REMARKS

AMENDMENTS TO THE DRAWINGS:

FIG. 2B

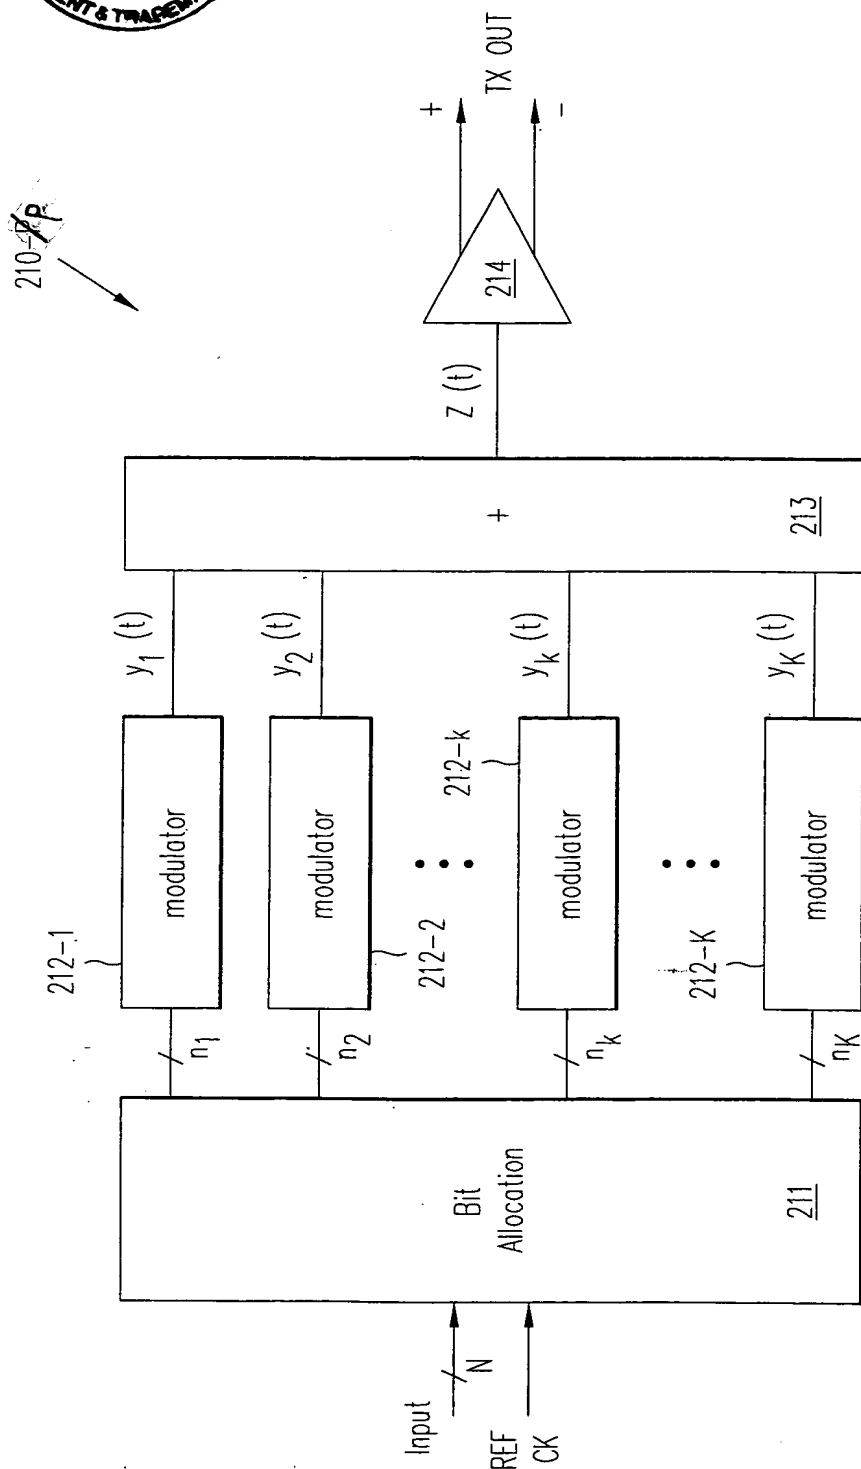
The attached sheets of drawings include changes to Figures 2B, 2C, 4, 5, and 9. These figures have been modified to correct for typos. Figure 2B has been modified to replace the label 210-P with 210-p. Figure 2C has been modified to replace the label 220-P with 220-p. Figure 4 has been modified to replace the label 212-R with 212-k and to delete an extra parenthesis from the caption for multiplier 410. Figure 5 has been modified to replace the label 222-K with 222-k. Figure 9 has been modified to replace the label 210-P with 210-p and replace the label 220-P with 220-p. No new matter has been added by these corrections.
